MODIFICATION RECOMMENDED

6572A-09

S E R V I C E N O T E

6572A DC POWER SUPPLY, 0-20V, 0-100 A, 2000 W. MANUALLY CONTROLLED.

Figure 5

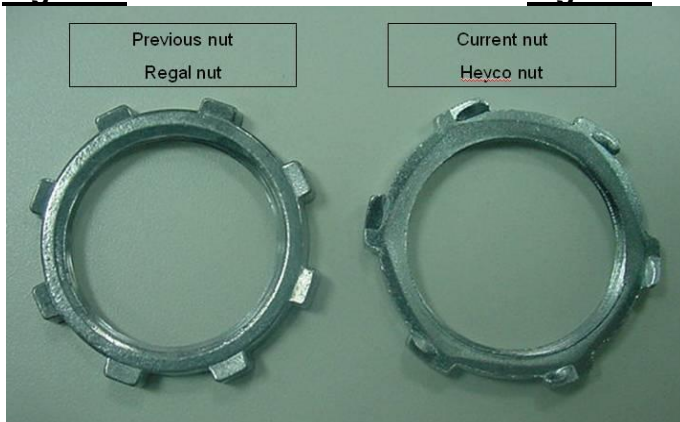
Figures 3 & 5 is representative of a not without locking ribs.

Figures 4 & 6 is representative of a nut with locking ribs.

The entire AC **INPUT SAFETY COVER** P/N 5040-1676 should be replaced.
